# Indiana-American Water Company, Inc.

July 9, 1997

Re: Contaminated Groundwater and Soil  
Franklin Power Products/Amphenol Facility  
Franklin, Indiana

Figure 8. Modeled pathlines from the FPP site: **Base case.**

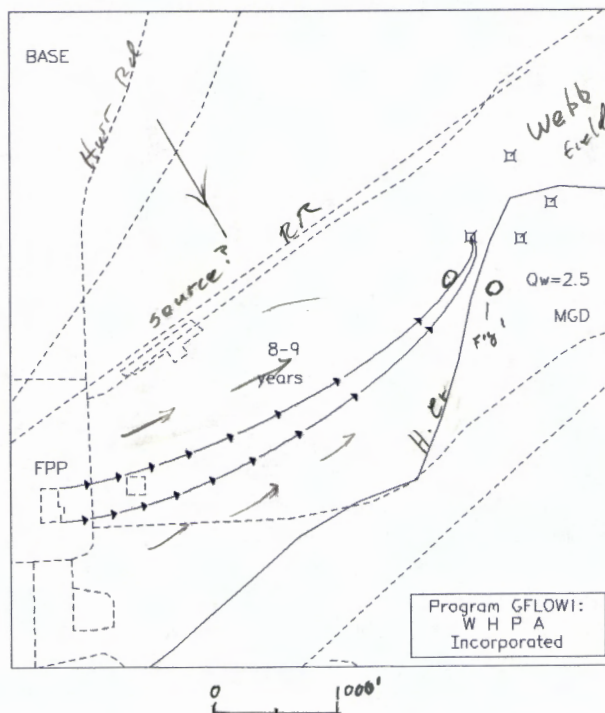
wells  
plots different  
than Fig 1
